Re: River Rock Ranch

MDP # 036-06

The City Staff Development Review Committee has reviewed River Rock Ranch Master Development Plan **MDP # 036-06**. Please find enclosed a signed copy for your files. Your plan was approved for acceptance; however please note the following conditions:

MASTER DEVELOPMENT PLAN

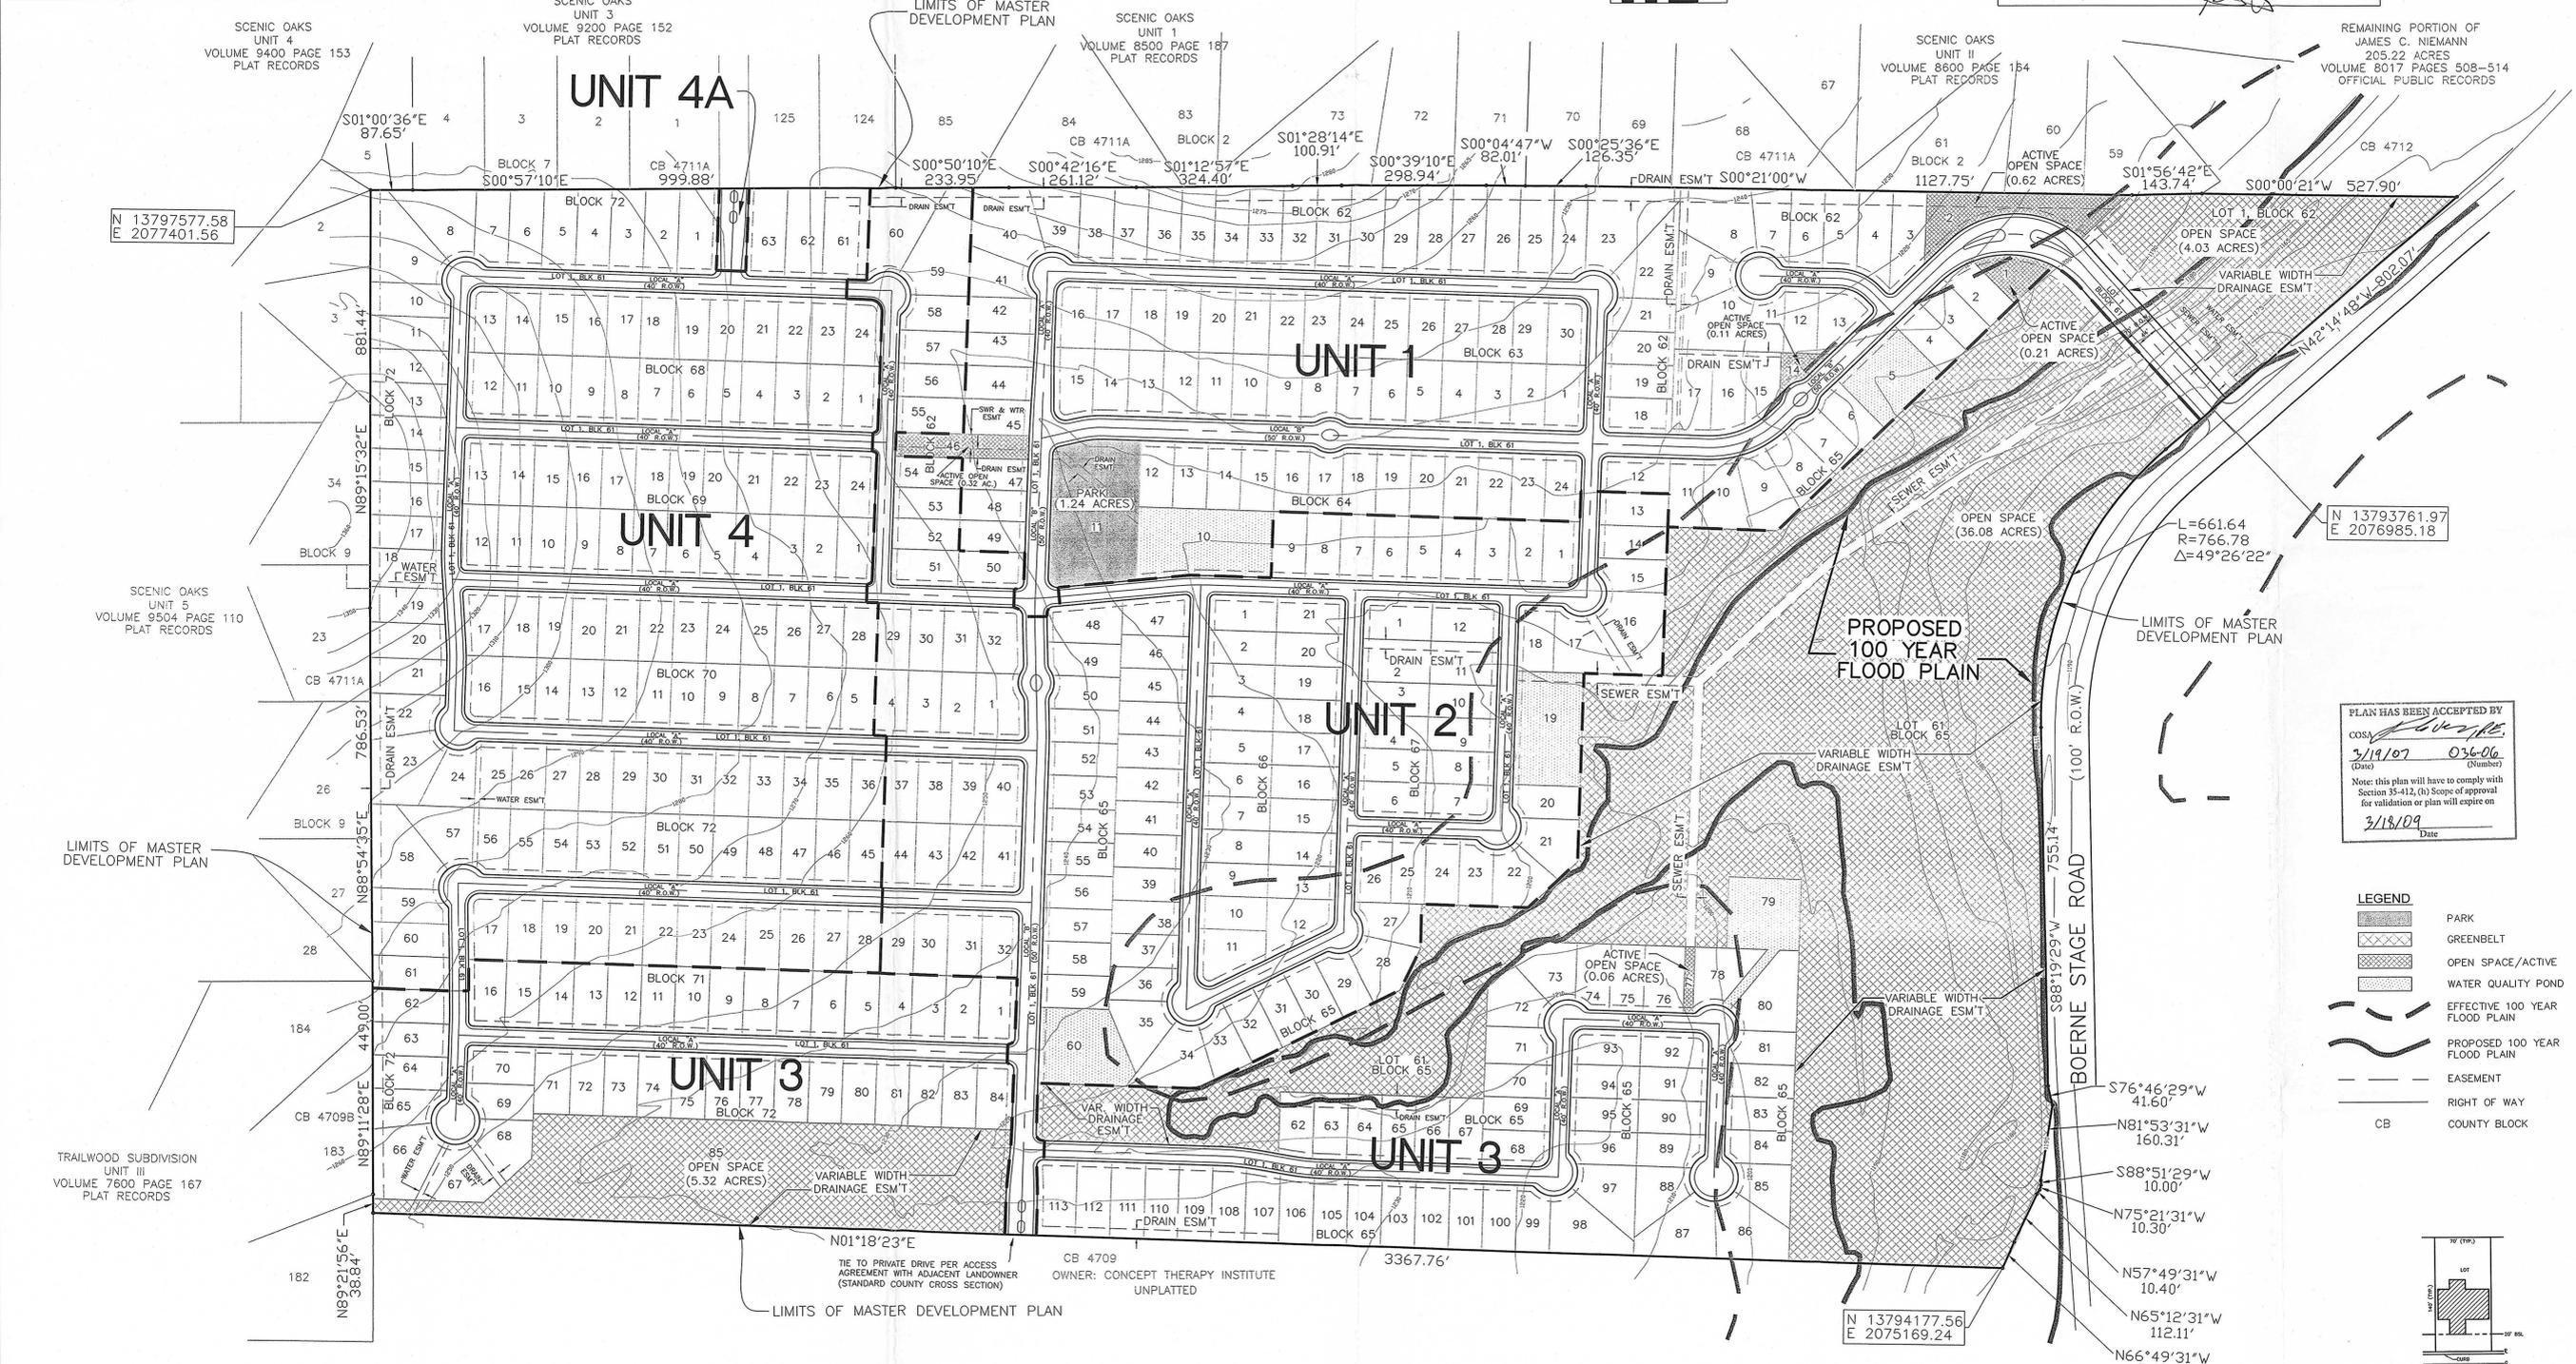
In consideration of public safety and convenience, excessive grades by reason of topography should be avoided in street layouts and arrangements. Any access and ROW issues along state facilities will need to be resolved with the **Texas Department of Transportation (TXDOT)**. For information about these requirements you can contact TXDOT at 615-5814.

DSD – Traffic Impact Analysis & Streets indicate that under the UDC listed below are some of the requirements and onsite improvements that are necessary and shall be provided by the developer, on and before the completion of River Rock Ranch MDP, at no cost to the City of San Antonio:

- All access driveways shall comply with UDC 35-506(r).
- All roadways shall conform to Table 506-2 Functional Classification System Description for Traditional Design Classification.
- All sidewalks shall comply with UDC 35-506(q).
- All access roadways shall provide clear sight distance on all existing and proposed roadways in order to provide adequate obstruction free viewing distances for approaching traffic. All signage, landscaping, and improvements shall be selected and located so as to not block these clear sight distances areas.
- The developer shall be responsible for providing right-turn deceleration lane, with storage lengths and bay taper in all the driveway access point approved by TxDot as it relates to the submitted TIA, UDC 35-506(d) Driveway #1.

- The parkland provided shall be shown as "Park" or "Open Space" on a plat; UDC section 35-503(e) *Designation of Parkland*.
- The parkland provided shall be dedicated to the Homeowners Association.
- The instruments creating the Homeowners Association shall be provided by the second application for plat approval; UDC section 35-503(e) *Designation of Parkland*.
- Parkland dedication shall be platted by the second phase of development; UDC section 35-503(f) *Development Phasing*.
- All amenities provided shall comply with standards and specification found in UDC section 35-503(h) *Credit for Park Facilities* and Table 503-4 if any credit is to be awarded.

Historic Preservation states the following: The Texas Sites Atlas indicates that no archaeological sites have been previously identified within the above referenced property. However, the project area is adjacent to Leon Creek and there is a probability that the property may contain sites, some of which may be significant, in particular along Leon Creek. Thus, before any work that might affect any sites is begun, a qualified professional should conduct an archaeological investigation (reassessment) of the property.

- 2003 Tree Preservation ordinance standards per UDC Section 35-523 – a Tree Preservation Plan has been approved for this subdivision and Master Tree Permit AP # 1284281 was issued. Please include this AP number with future plat and building permit affidavits. Plat will require additional \$ 75.00 review fee with affidavit.

- 100 year Flood Plain Shown and Buffering (If applicable)
- Significant Recharge Features and Buffering (If applicable)
- Category Letter for All Site Specific Plats (If Category 2 or 3, an Aquifer Protection Plan is required (If applicable)
- Additionally, a Water Pollution Abatement Plan or Contributing Zone Plan must be submitted to and approved by the Texas Commission on Environmental Quality (TCEQ) prior to construction.

- According to the Aquifer Protection Ordinance# 81491, Section 34-914, floodplain buffering may be required. Any existing wells located on the property shall be plugged. For plugging procedures, please contact Kirk Nixon at 233-3523.

- Traffic controls shall be warranted as per the Texas Manual on Uniform Control Devices and approved by Bexar County.
- Add a westbound right-turn deceleration lane at the sites main entrance on Boerne Stage Road through a separate permit from Bexar County.
- Upgrade and maintain a minimum county road section through the Concept Therapy Institute property as per the written agreement submitted with this Master Development Plan.
- Secondary access must be finalized prior to the approval of any plat or combination of plats exceeding 125 dwelling units as per UDC 35-506(e)(7).
